## Department of Transportation

#### MEMORANDUM

**SUBJECT:** ZC Case No. 22-13 – 4500 Massachusetts Avenue NW (Wesley Theological Seminary)

### **Figure 1 | Proposed Site Circulation**

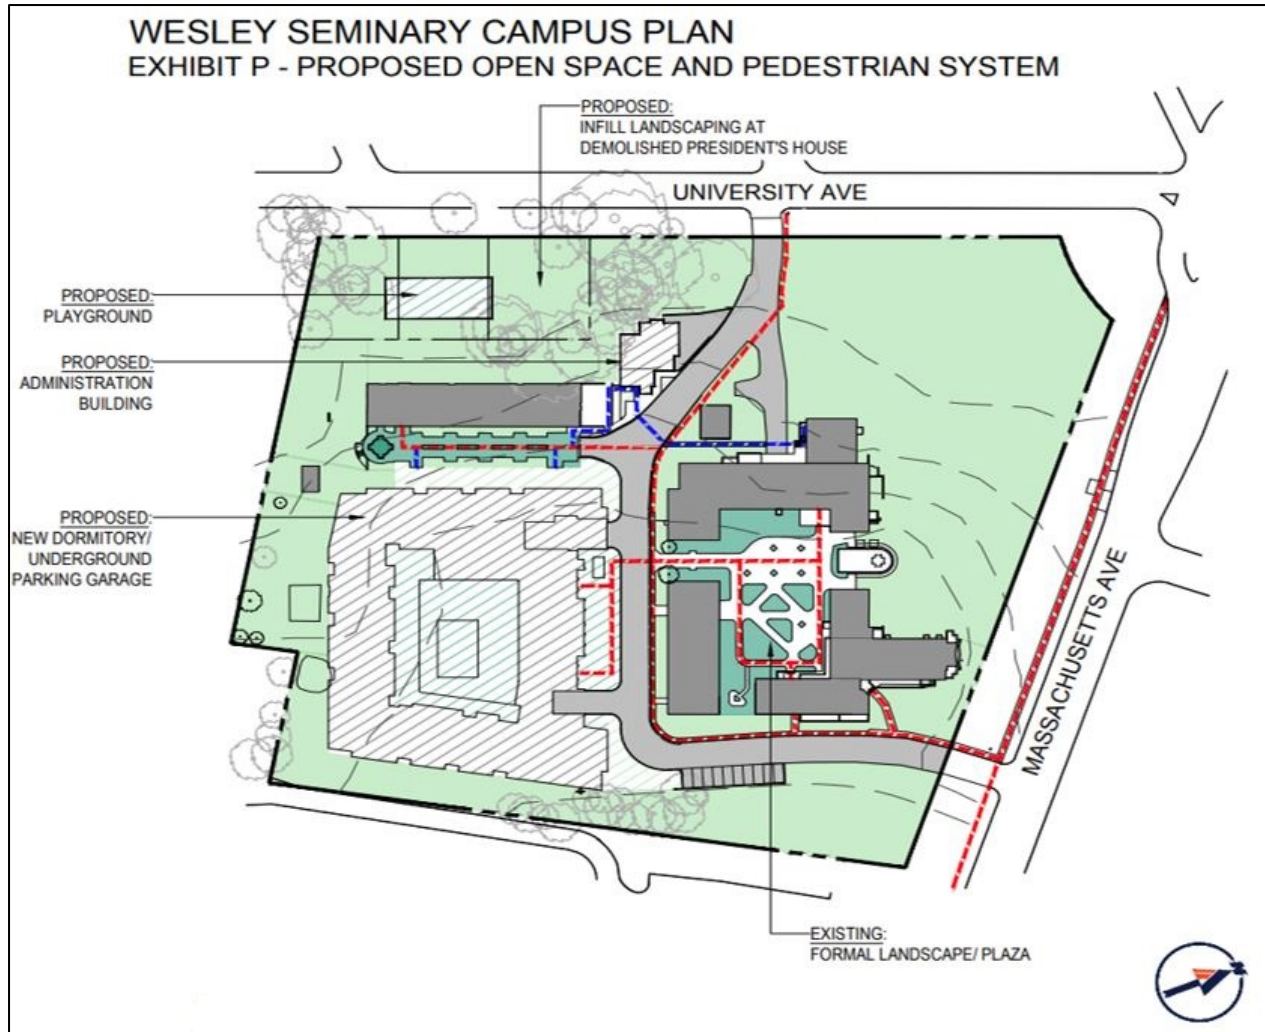
The campus will continue to be accessed mainly through existing curb cuts on University Avenue for and Massachusetts Avenue NW. No vehicle access changes are proposed as part of the 2022 campus plan.

Pedestrian access is also mainly provided from Massachusetts Avenue as there is no sidewalk on University Avenue. There is a pedestrian connection between the Wesley Seminary and American University that is controlled by a pedestrian gate and key fob. No pedestrian access changes are proposed with the 2022 campus plan, however, DDOT is requesting the missing sidewalk, curb ramps, ADA facilities, and leadwalk be installed on the University Avenue side of Campus.

**Figure 4 | Existing Pedestrian Facilities**

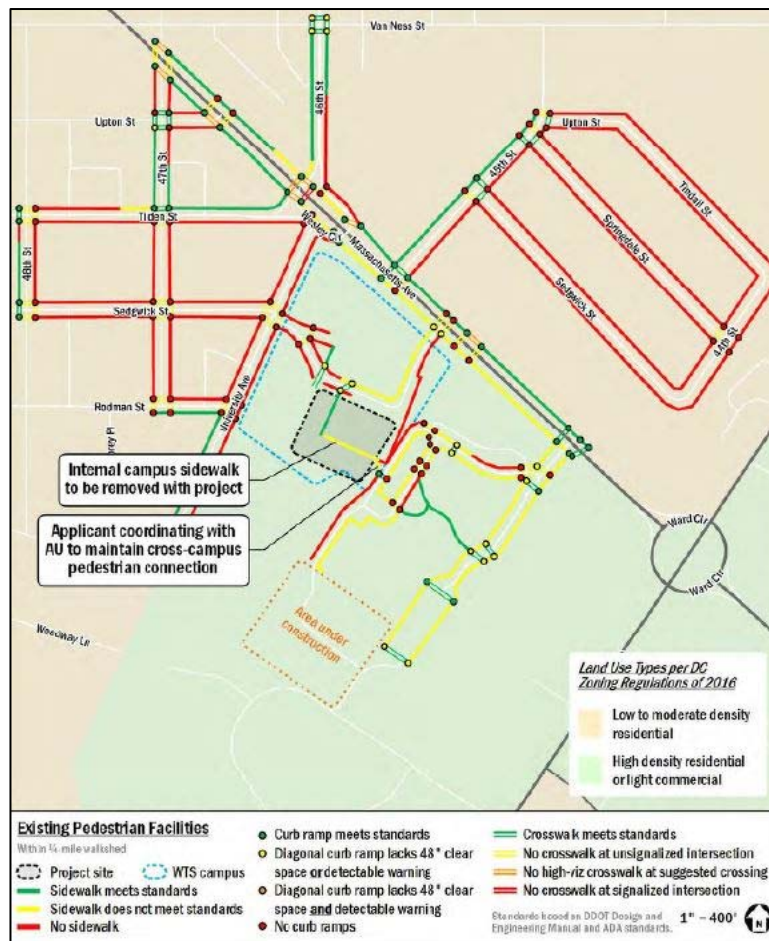
The Applicant's inventory of the pedestrian infrastructure in the vicinity of the campus, as shown in Figure 4 shows that there are significant missing connections in the study area, particularly along University Avenue. To help offset the projected increase in traffic volumes and to encourage non-automotive travel to and from Campus, DDOT requests the Applicant commit in the TDM Plan and PMP to installing the missing sidewalk along University Avenue, including the missing ADA facilities with a leadwalk into campus, and install wayfinding signage on-site for residents seeking to walk to American University campus.

- Prior to the Spring 2024 semester, fund and construct the following pedestrian improvements:
  - A sidewalk along the east side of University Avenue NW between Massachusetts Avenue and Rodman Street, subject to DDOT approval, with a leadwalk into campus at the site driveway.

- All missing curb ramps, crosswalks, and signage at the intersections of University Avenue at Rodman Street and University Avenue at Sedgwick Street/Site Driveway, subject to DDOT approval; and

- Wayfinding signage on the Wesley Seminary campus directing students to the gated connection to the American University Campus.
- In the TDM Plan, state the minimum number of long-term and short-term bicycle parking spaces to be provided. Of the long-term spaces, clarify that at least 50% will be located horizontally on the floor of the storage room, 10% will be served by electrical outlets for e-bikes/scooters, and 5% will be designed to accommodate larger cargo/tandem bikes (10 feet by 3 feet size). Each bike storage room will include a repair station; and

**Figure 5 | Existing, Planned, and Proposed Bicycle Facilities**

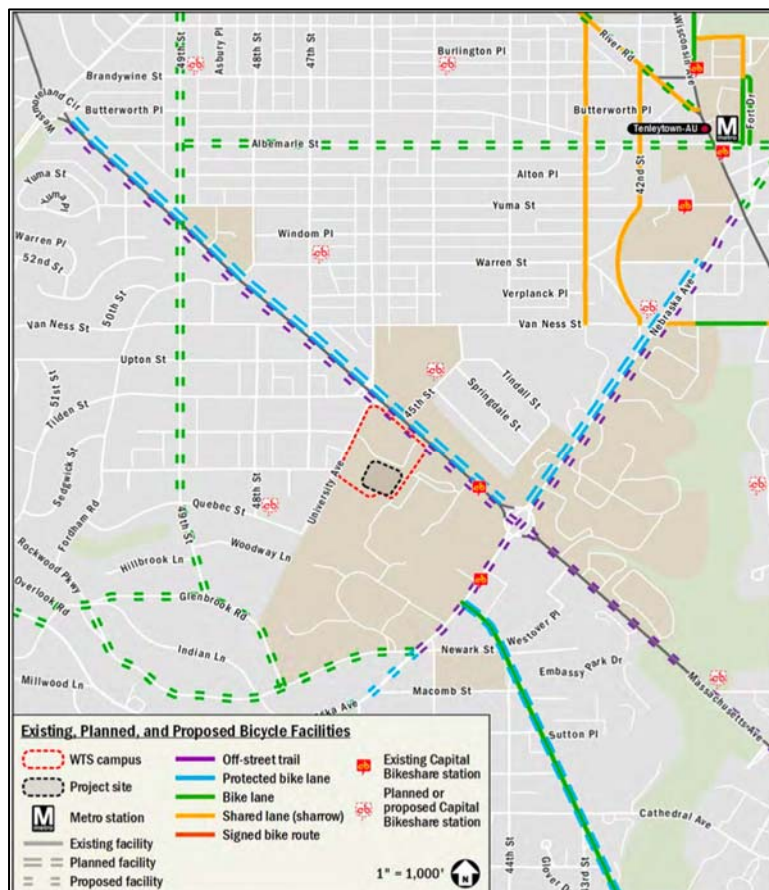
The Applicant will be upgrading all on-campus short-term bicycle parking to U-racks and installing an additional 10 bicycle racks due to increased demand. As shown on Figure 5 below, there are currently not many existing bicycle lanes or trails within ½ mile of the site, however there are several planned facilities in the future.
